24 Montgomery Avenue, Takoma Park  
HRC Case No. 37103-08A  
Takoma Park Historic District

**MEMORANDUM**

SUBJECT: Historic Area Work Permit #474425, window replacement

The Montgomery County Historic Preservation Commission (HPC) has reviewed the attached application for a Historic Area Work Permit (HAWP). This application was **Approved with Conditions** at the February 13, 2008 meeting.

PHOTOGRAPHS

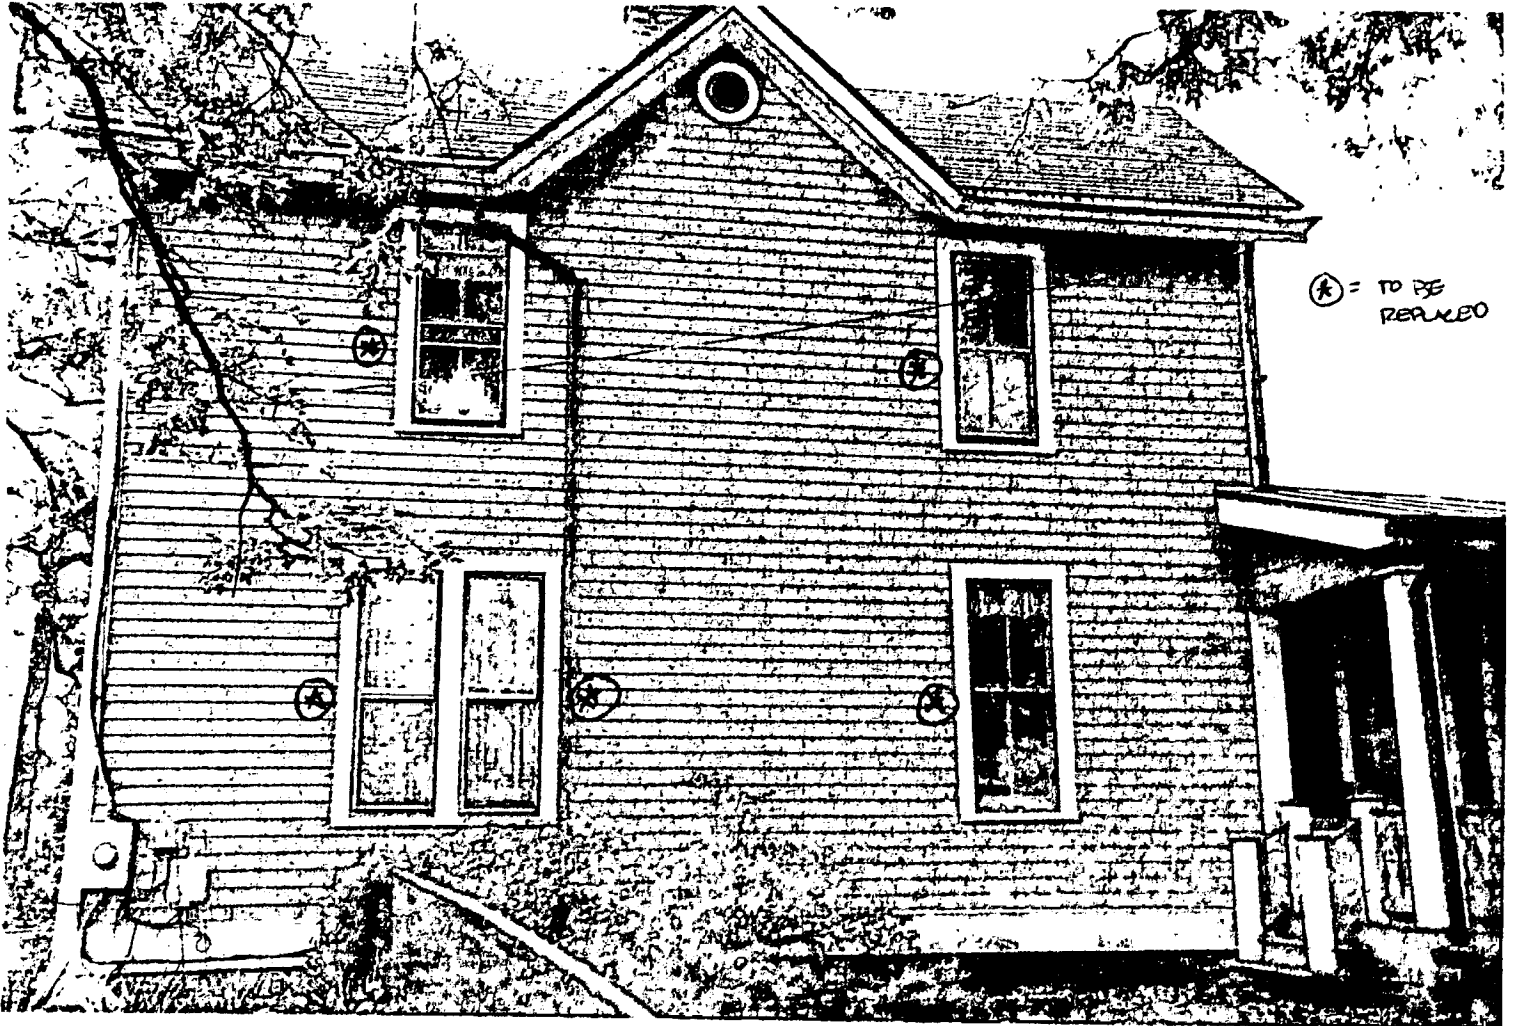
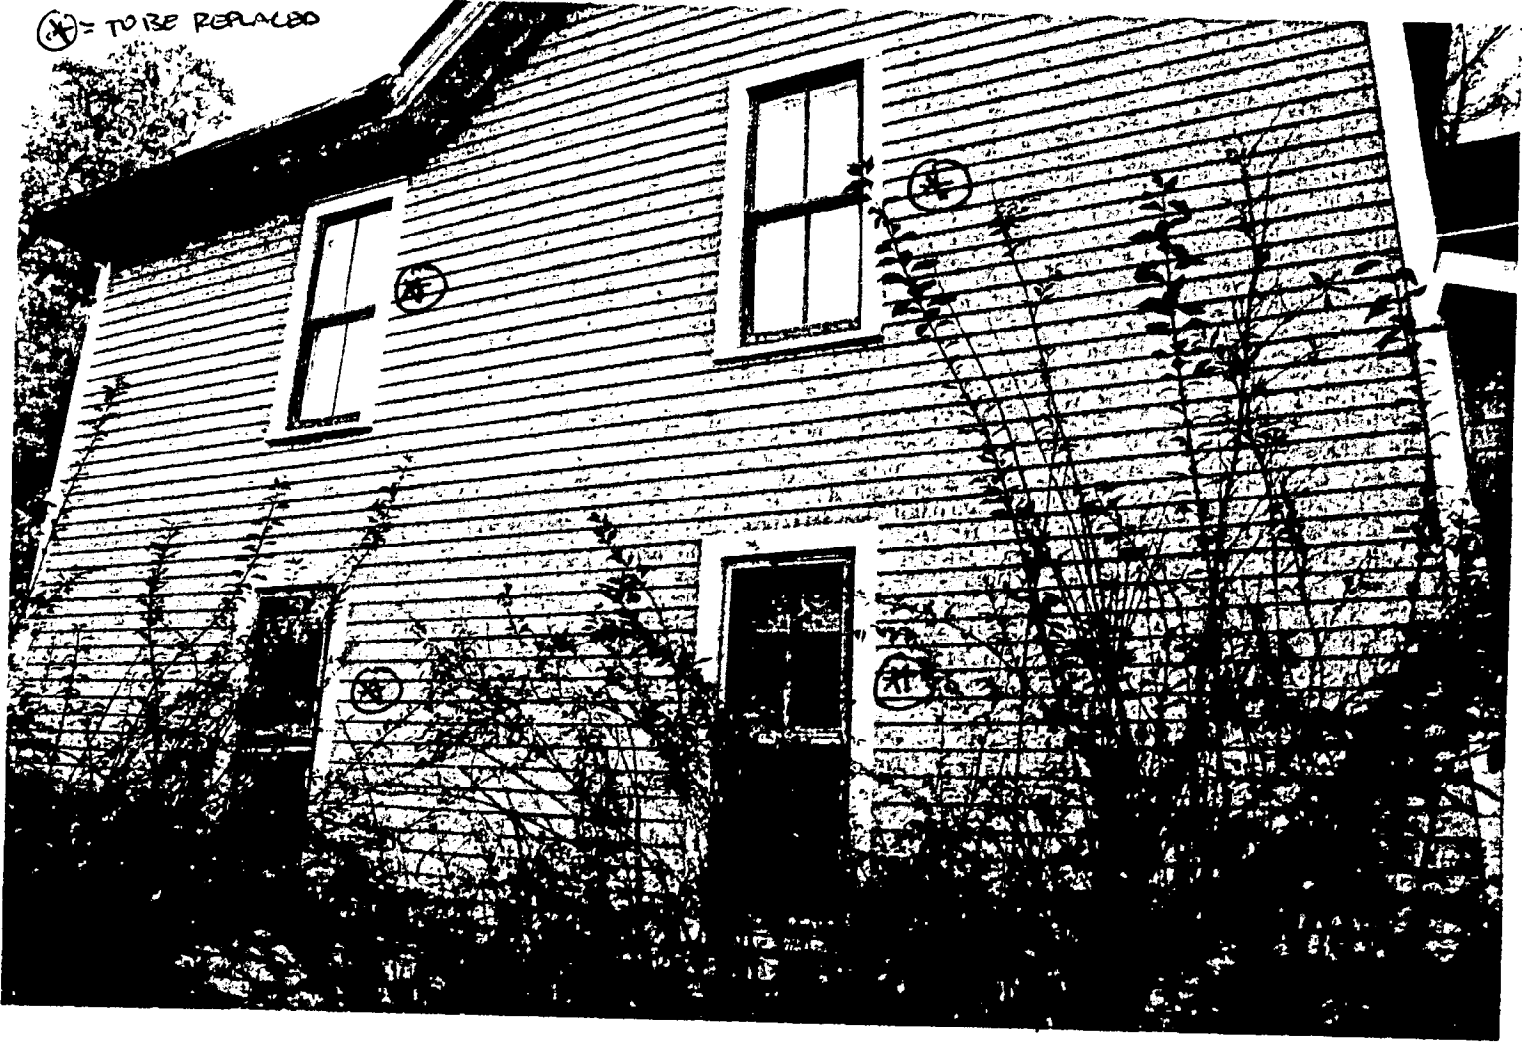
FRONT OF HOUSE : MONTGOMERY AVE  
ALL WINDOWS EXCEPT #1111 TO BE REPLACED

SIDE VIEW - FAIRFAXY 111  
ALL WINDOWS IN PHOTO TO BE REPLACED

BOTH 2<sup>ND</sup> FLOOR WINDOWS AND FAR RIGHT 1<sup>ST</sup> FLOOR WINDOW TO BE REPLACED

FRONT OF HOUSE - MONTGOMERY AVE  
ALL WINDOWS EXCEPT THIS TO BE REPLACED

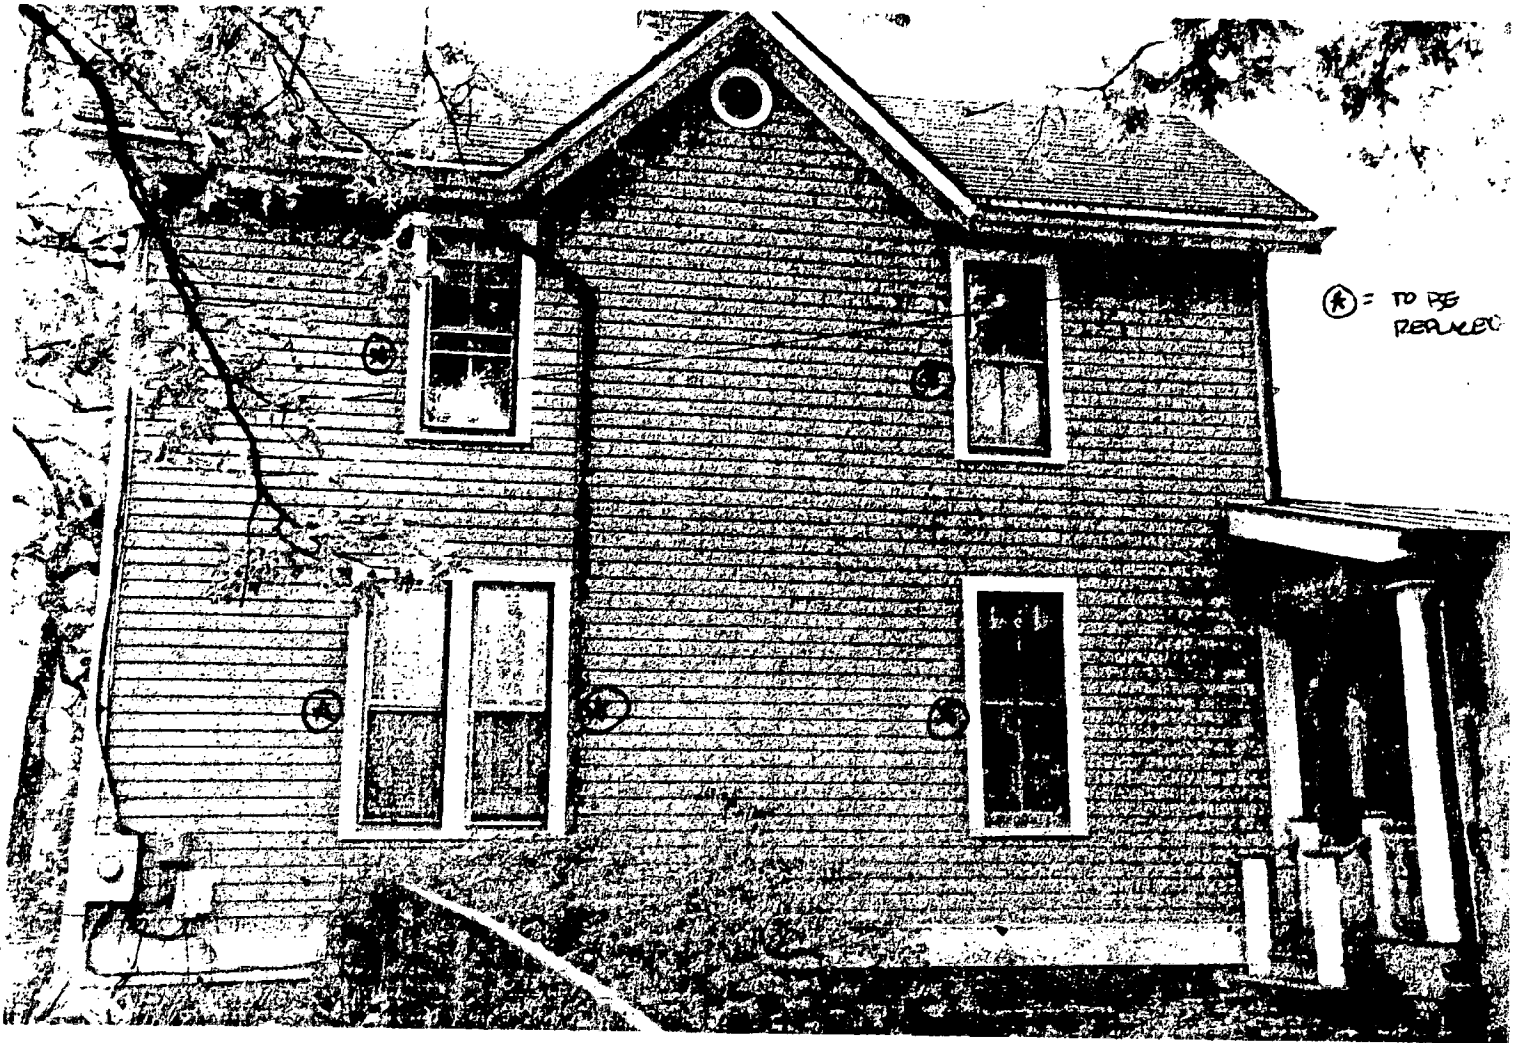
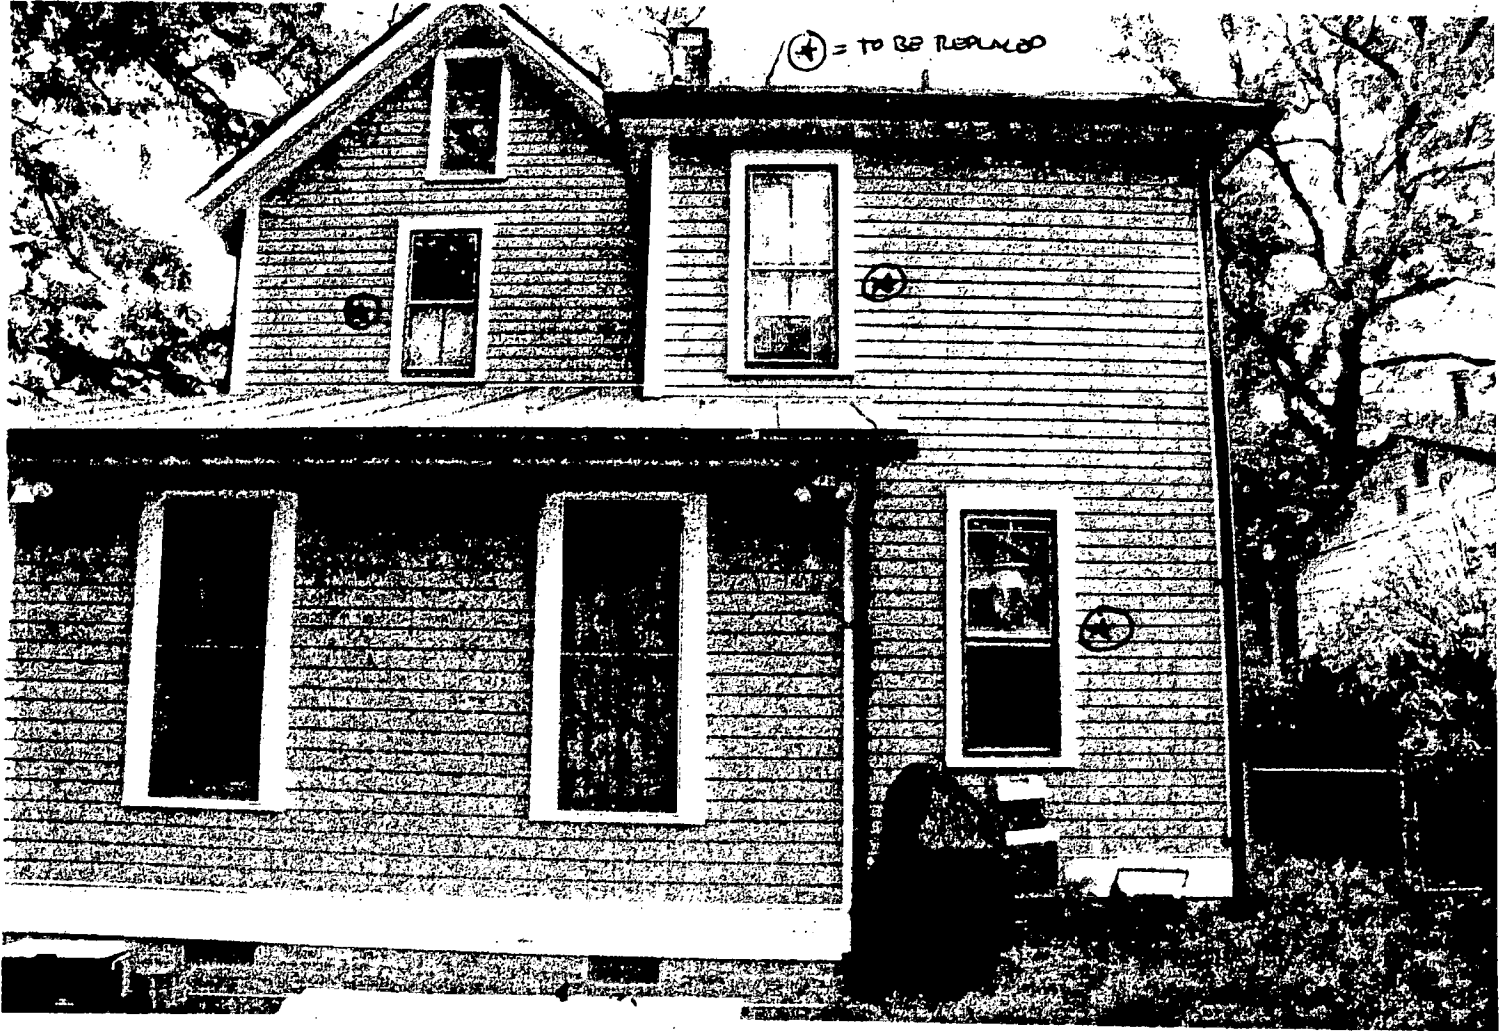
ALL WORK SHOWN IN PHOTO TO BE REPAIRED

BOTH 2<sup>ND</sup> FLOOR WINDOWS AND FIRE DOOR 1<sup>ST</sup> FLOOR WINDOWS TO BE REPAIRED
